TECHNICAL NOTE

2024s0643
Ledgard Mill
Helen Davies
27nd June 2024
Olivier Saillofest BEng MSc CEng
MCIWEM C.WEM
John Panesar BEng (Hons) CEng
MICE
Building on void - Technical parameters

JBA was commissioned by Helen Davies to address concerns raised by the Environment Agency regarding the design of a proposed building on stilts / on a void at Ledgard Mill, Mirfield (planning application ref: 2023/93539).

Figure 1: Building on void parameters - sketch (not at scale)

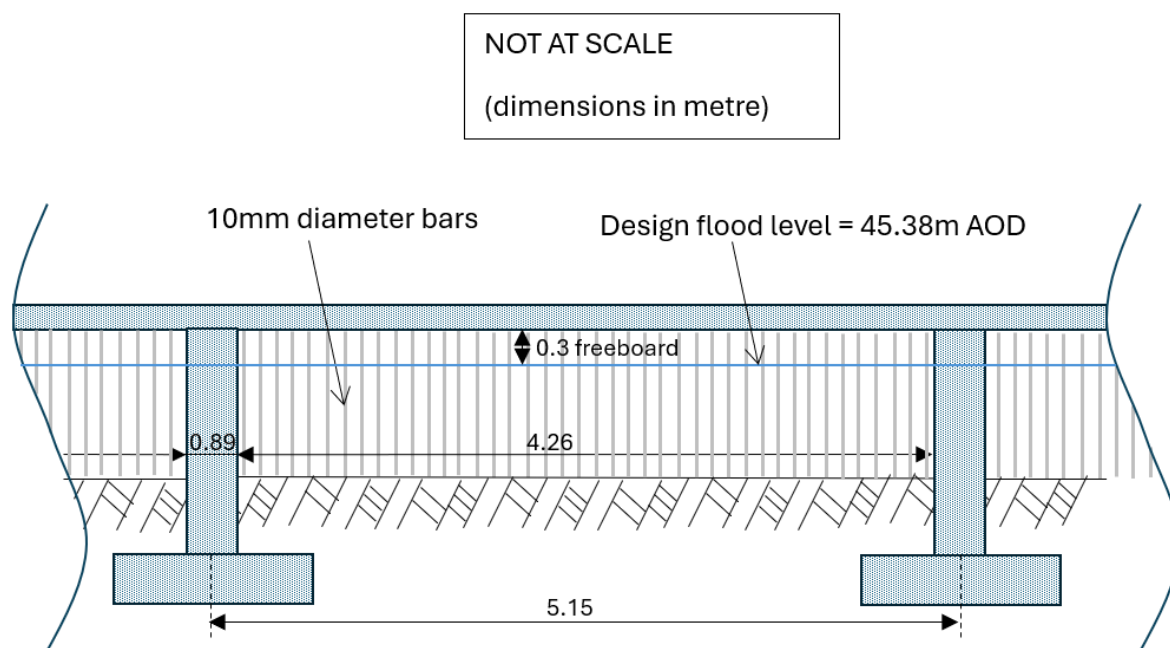
- 1 Confirmation of the single design flood level (1%AEP + appropriate climate change allowance), including the source of this data.
- 2 Clear detailed drawings of the proposed void solution including the dimensions of the openings.

In line with the proposed void solution modelled by JBA Consulting in 2019, it is proposed to use the following design parameters for the building on void.

- Void base level: at existing ground level (c. 44.55m AOD)
- Void opening width: 4.26m for every 5.15m length of wall
- Pier (between void inlets) width: 0.89m
- Minimum void soffit level: 45.68m AOD
- Open void length per length of wall: 4.26m for every 5.15m length of wall, on the sides of the proposed building facing incoming overland flows (i.e. north-eastern and south-western sides)
- Opening through side walls (parallel to overland flows): No
- Solid to void ratio within void (due to vertical walls, supporting frame, beams, etc): 17%
- Vertical bars: yes, 10mm diameter with 100mm spacing

In line with standard practice for the design of buildings on void, a minimum freeboard value of 300mm above the 'design' flood level will be used to set the void's soffit/ceiling level (as illustrated in Figure 1). Following discussion with the Design Team, it is confirmed that the soffit level of the building on void will be set to 46.33m AOD, i.e. approximately 950mm above the design flood level. As a result, the proposal complies with standard practice.

Figure 2: Flood risk impact analysis

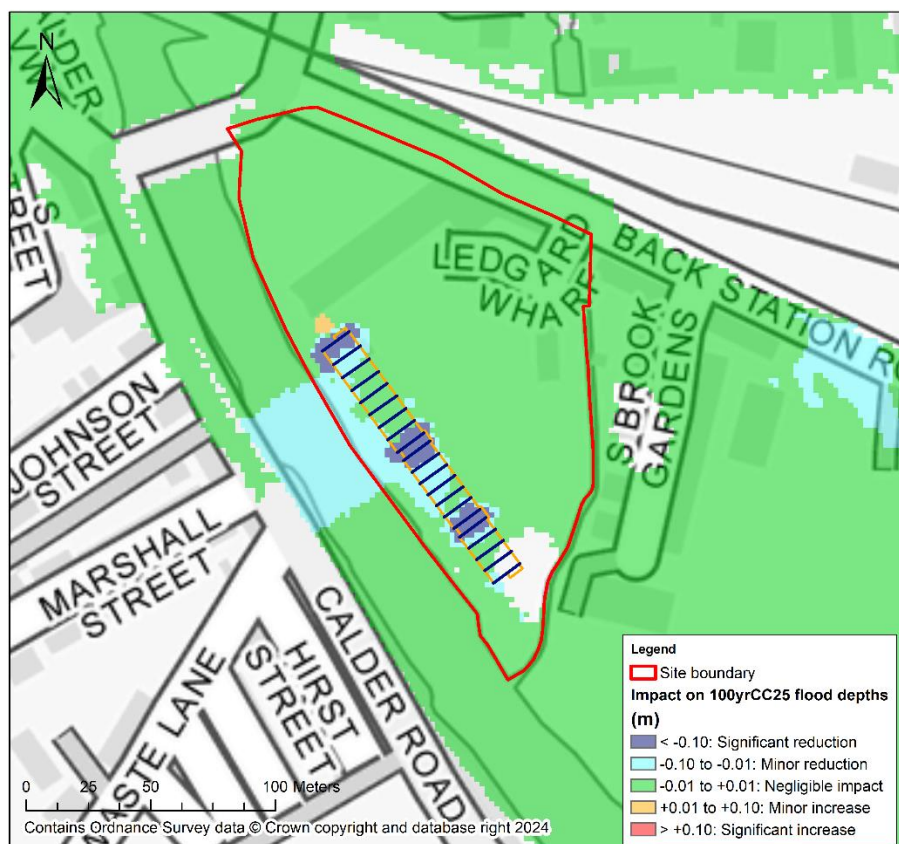
- 4 An assessment of the impact of the building on flood flow into and out of the space. This should prove that the proposed solution will not slow down the ingress or egress of flood water on the site. The reason for this is that if it slows inflow, it could deflect flood water onto others. Depending on the specifics, this may need some kind of hydraulic calculations. Details of the flooding mechanisms for the site would be useful here as well, so we can understand how quickly the site floods etc.

As a precautionary measure, the impact of the building on void was re-modelled using current modelling practice, i.e. using flow constriction lines with a 26% blockage value (i.e. $= (5.15 - (4.26 \times 90\%)) / 5.15$). The base of the void was kept to existing ground level (i.e. unchanged) and lateral walls were modelled as 100% impervious.

A comparison of the impact generated by the proposal based on current modelling practice was compared with the flood risk impact map documented in the 2019 Technical Note (see Figure 2).

Figure 2 shows a comparable impact on flood depths as the one documented in Figure 2-3 of the 2019 Technical Note and confirms the proposal will not increase flood risk across third-party land.

Figure 3: Impact on flood extent

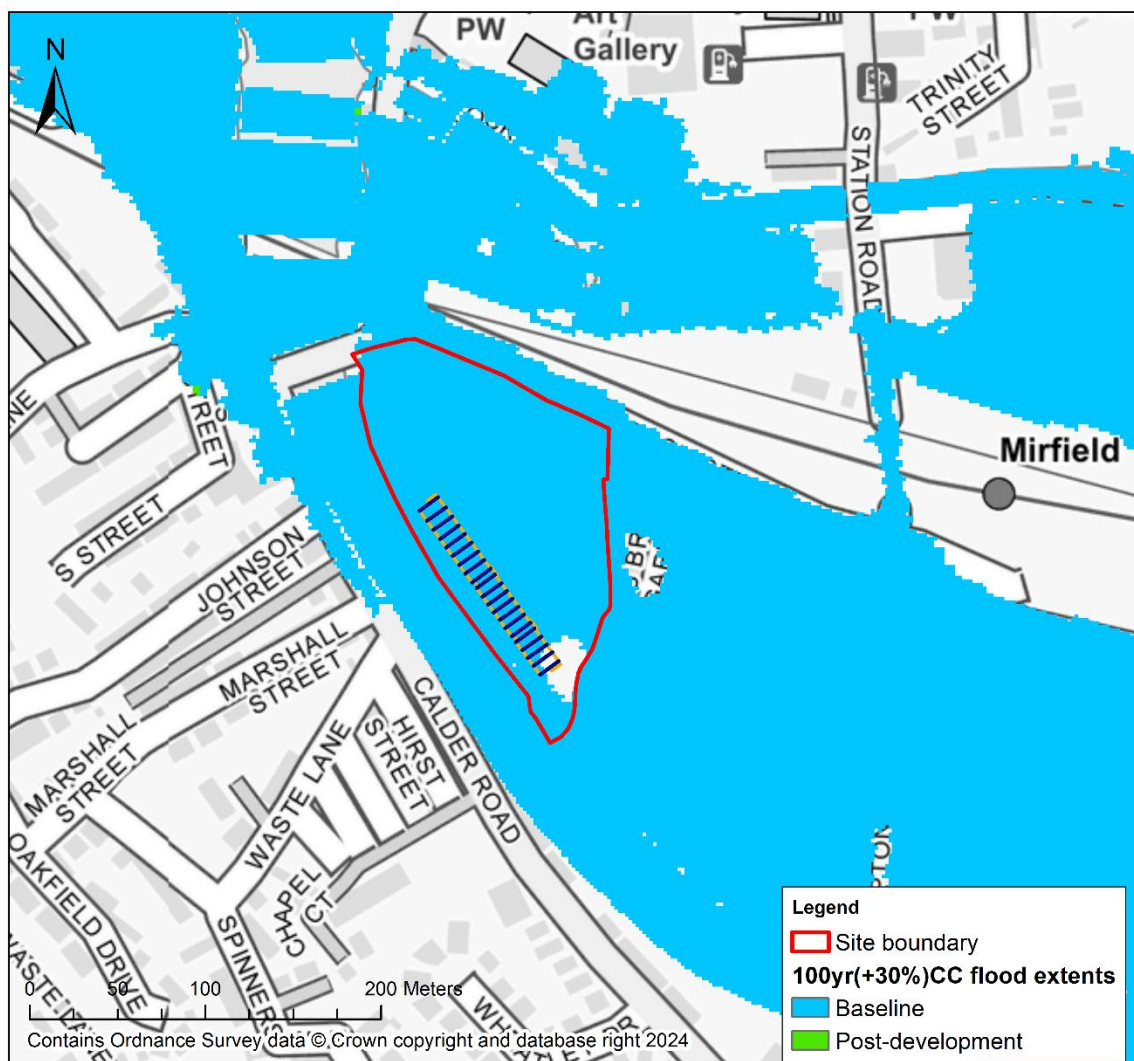
- 5 Confirmation of the soffit level of the void space compared to the design flood level.
- 6 Clear details of the comparison between baseline and "with scheme" flood extents and depths for the design flood event. This will need to show that there is no increase in flood risk offsite. This should include comparisons of flood levels (in mAOD) and flood extents.

Further to the analysis undertaken under Section 2.4, a comparison between the 100-year with (+30%) climate change baseline and post-development flood extents was carried out (See Figure 3).

Figure 3 shows that the post-development flood extent is completely overlapped by / does not extend beyond the baseline flood extent. As a result, this confirms that the proposal does not increase flood extents elsewhere.

Figure 4: Impact of 100% blocked building on void (extract from 2019 Technical Note)

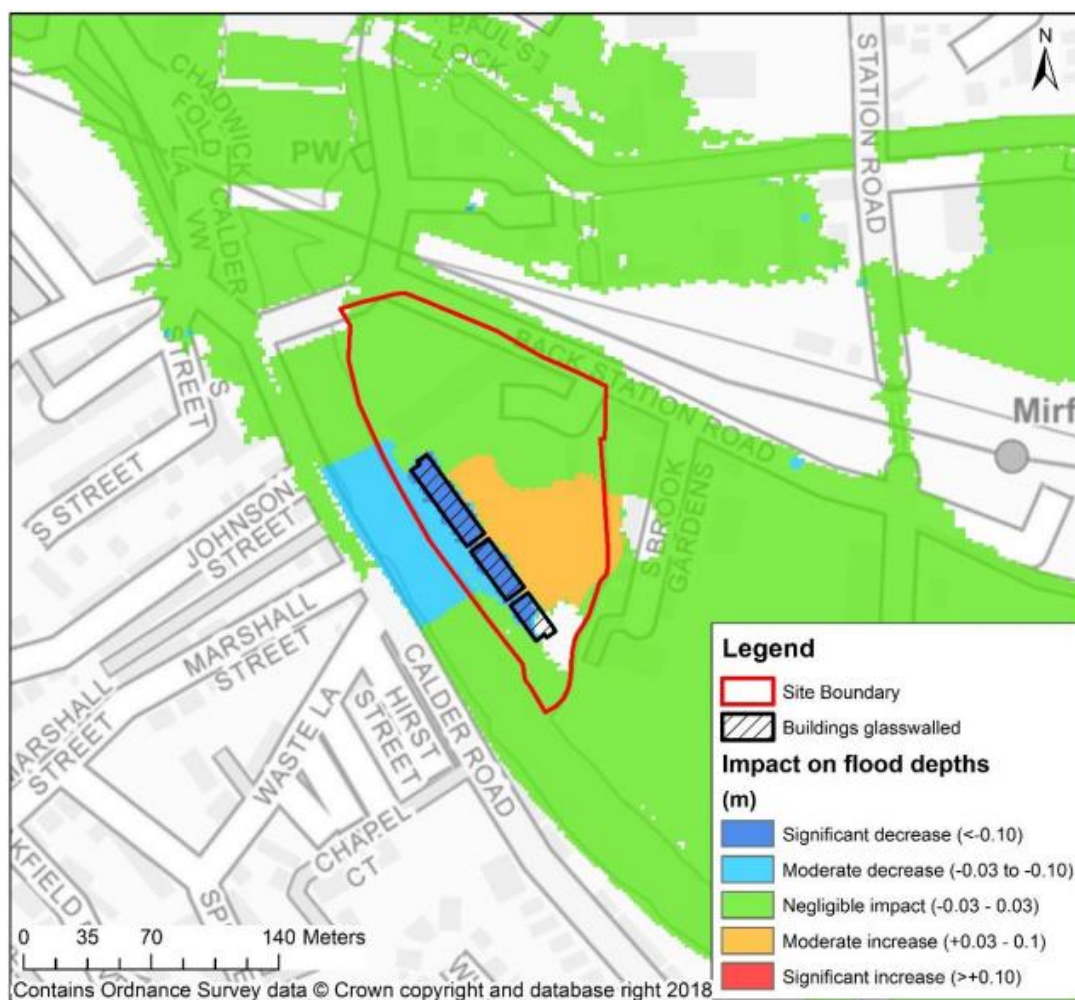
- 7 Details of the comparison between baseline and 100% void blockage scenario for the design event. This should include comparisons of flood levels (in mAOD) and flood extents. This is needed to understand the worst-case scenario of all maintenance measures failing and the void space becoming blocked. If the impacts of this are significant, then the risk may not be considered acceptable as the proposal will be introducing the potential for an unacceptable impact that wasn't there previously.

The impact of a 100% blockage of the building's void was initially modelled by JBA in 2019 as part of a sensitivity analysis and is documented in Appendix C4 of their Technical Note (see extract below).
